ADDENDUM NO. 1
TO CONTRACT DOCUMENTS FOR THE
PALO ALTO FLOOD BASIN TIDE GATE STRUCTURE IMPROVEMENTS PROJECT
Project No. 10394001 Contract No. C0630

ADDENDUM NO. 2
TO CONTRACT DOCUMENTS FOR THE
PALO ALTO FLOOD BASIN TIDE GATE STRUCTURE IMPROVEMENTS PROJECT
Project No. 10394001 Contract No. C0630

ADDENDUM NO. 3
TO CONTRACT DOCUMENTS FOR THE
PALO ALTO FLOOD BASIN TIDE GATE STRUCTURE IMPROVEMENTS PROJECT
Project No. 10394001 Contract No. C0630

PROJECT NAME AND SHEET DESCRIPTION:
**PALO ALTO FLOOD BASIN
TIDE GATE STRUCTURE
IMPROVEMENTS PROJECT**
New Steel Bulkheads

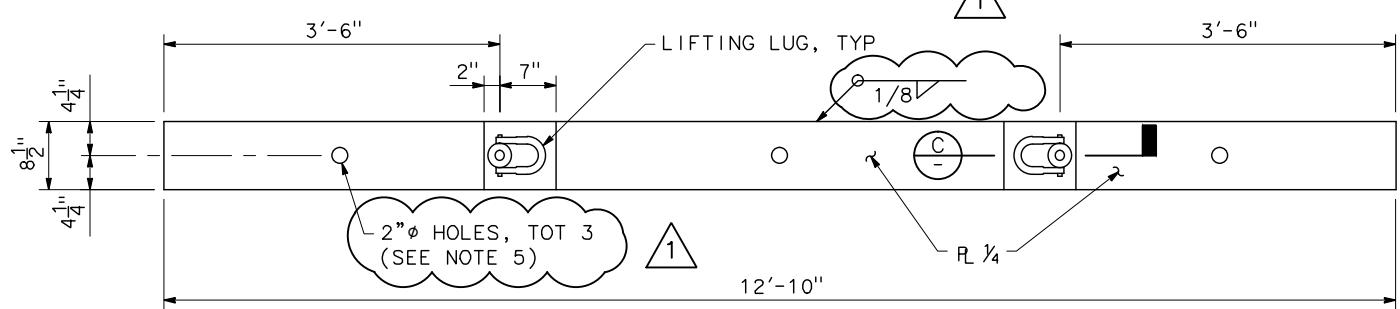
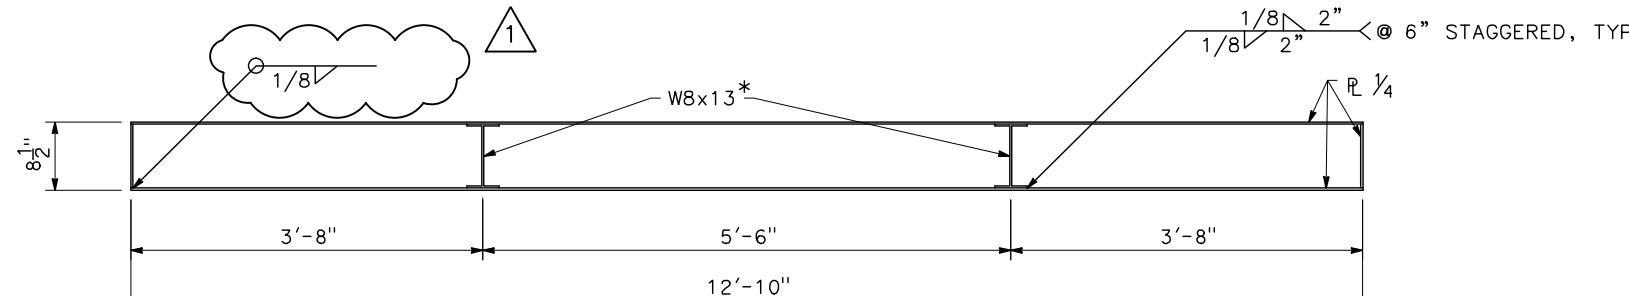
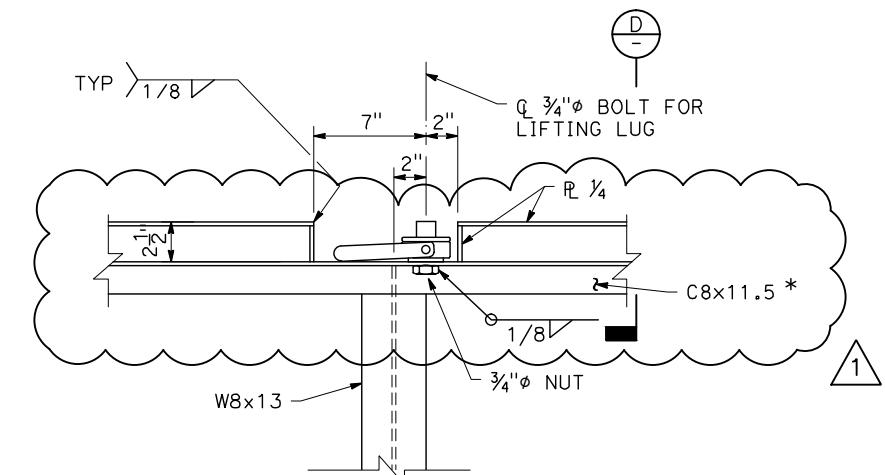
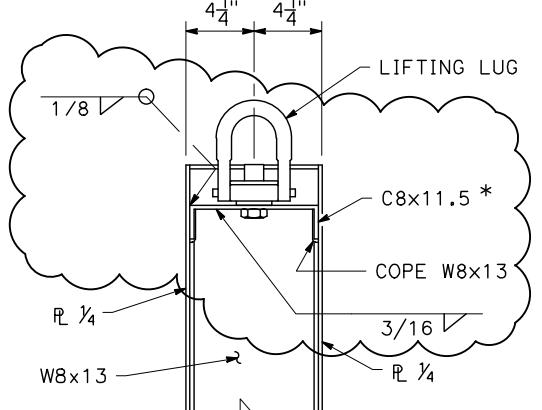
Question 15	Our steel fabricators are concerned that the galvanizing of the new steel bulkheads quite possibly will warp the structure out of its specified tolerances. They suggest either powder coating or stainless steel. I don't think powder coating would hold up. Any chance of changing the requirements to stainless steel?
Response 15	Please see revisions to drawings S-13 thru S-15 as well as revisions to Specification SECTION 32. METAL STRUCTURES in this Addendum No. 3.

REV	DESCRIPTION	DATE	APPR	REFERENCE INFORMATION AND NOTES
1	BULKHEAD CHANGES	6/17	MB

1. ALL MATERIAL SHALL BE EITHER ALUMINUM OR STAINLESS STEEL. STRUCTURAL SHAPES CAN BE FABRICATED OUT OF PLATE.
2. FABRICATE 2 BULKHEADS AS SHOWN.
3. RUBBER SHEETING SHALL BE ATTACHED WITH 1/4"Ø STAINLESS STEEL RIVETS WITH 5/8"Ø (MIN) WASHER AT 12" O.C.
4. LIFTING LUGS SHALL BE CROSBY STAINLESS STEEL NO. 1065048 WITH 3500# LIFTING CAPACITY, OR EQUAL
5. CUT 2"Ø HOLES IN TOP AND BOTTOM PLATE, AND C8x11.5

* NOTE: THE WEIGHT OF STRUCTURAL SHAPES ARE FOR STEEL.
ALUMINUM SHAPES WILL WEIGHT LESS PER FOOT.
